Technical Analysis and Findings
Utah Coal Regulatory Program

PID: C0150018
TaskID: 4762
Mine Name: DEER CREEK MINE
Title: TRANSFER WELL MONITORING

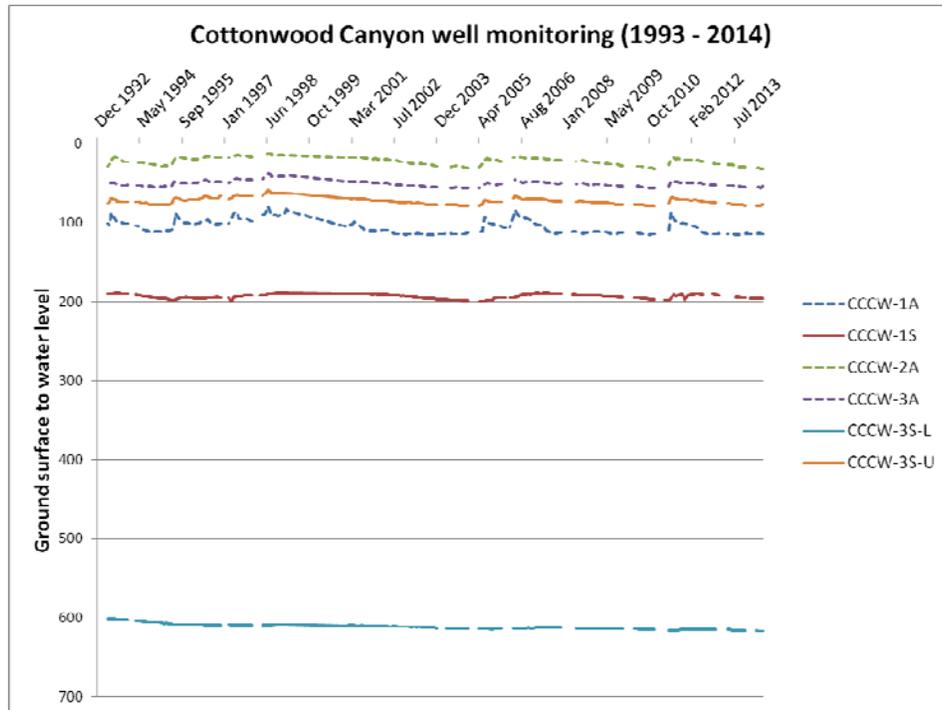
The application to remove the six wells: CCCW-1A, CCCW-IS, CCCW-2A, CCCW-3A, CCCW-3S U, and CCCW-3S L, from the Deer Creek water monitoring program and add them to the Trail Mountain water monitoring program adequately addresses hydraulic performance standards as given under Ground-Water Monitoring in R645-301-731.210. The application to add a copy of the Cottonwood Canyon Creek 1992 hydrogeologic investigation pertaining to these wells to the Trail Mountain MRP adequately addresses hydraulic performance standards as given under Probably Hydrologic Consequences (PHC) Determination R645-301-728. The wells are located in Cottonwood Canyon Creek and have continuously monitored water levels at three locations in the unconfined alluvial aquifer and at three locations in confined bedrock aquifers from 1993 to the present. The water level in each well has been relatively stable with no major long term trends since monitoring began (Figure 1).
